Form 3160-5 (August 2007)

SUNDRY NOTICES AND REPORTS ON WELLS

•			
DEVON ENERGY	PRODUCTION COMPAN	Y LP		
Vell Name: TODD 22P FEDERAL #16	Field: INGLE WELL:	5.	ᅱ	
ocation: 660' FSL & 610' FEL; SEC 22-T235-31E	County: EDDY	State: NM	ᅱ	
levation: 3433' KB; 3420' GL; 13' KB to GL	Spud Date: 7/14/04	Compl Date: 8/24/04		
PI#: 30-015-32735 Prepared by: R.Slack	Date: 6/24/15	Rev:	\neg	
221	1 22	,	\neg	
		TOPS PER CMPL RPT		
17-1/2" hole		Rustler 646		
13-3/8", 48#, H40, STC @ 865'		Salado 969 B.Salt 4106	İ	
Cmt'd w/870 sx to surface		Delaware 4316		
		Cherry Canyon 5257		
8		Brushy 6899 Bone Spring 8171	l	
		Bone Spring 0171

Todd 22P Fed 16

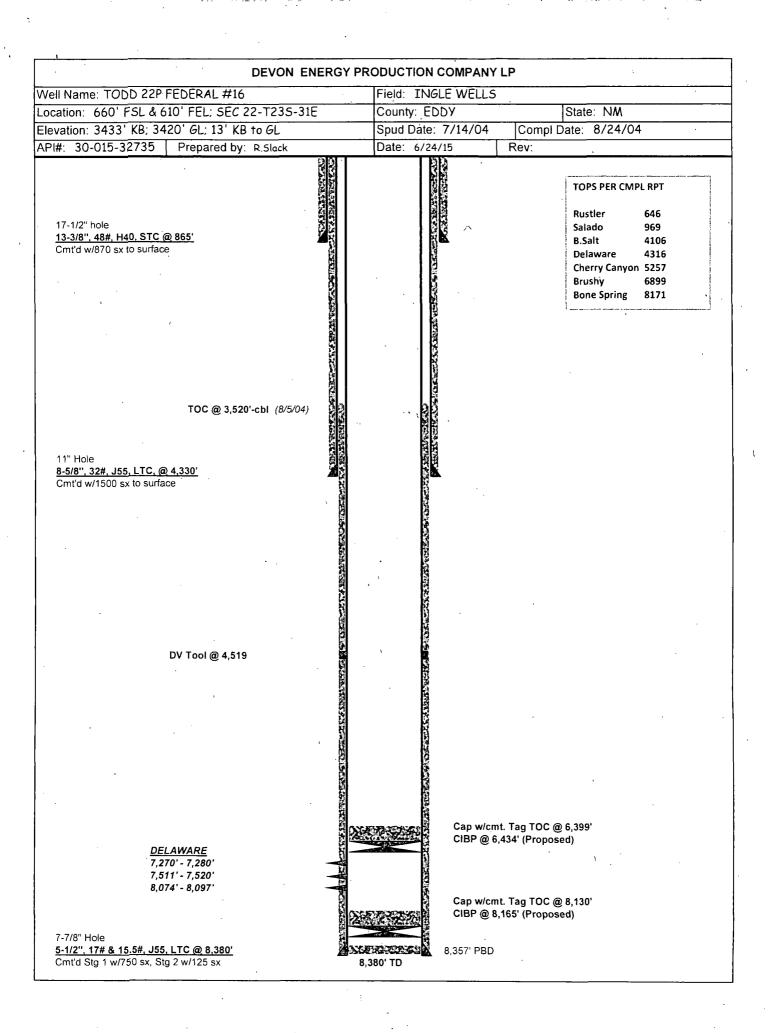
1. Operator shall set a CIBP at 7,220' (50' above top most perf) and place 173' Class C cement on top.
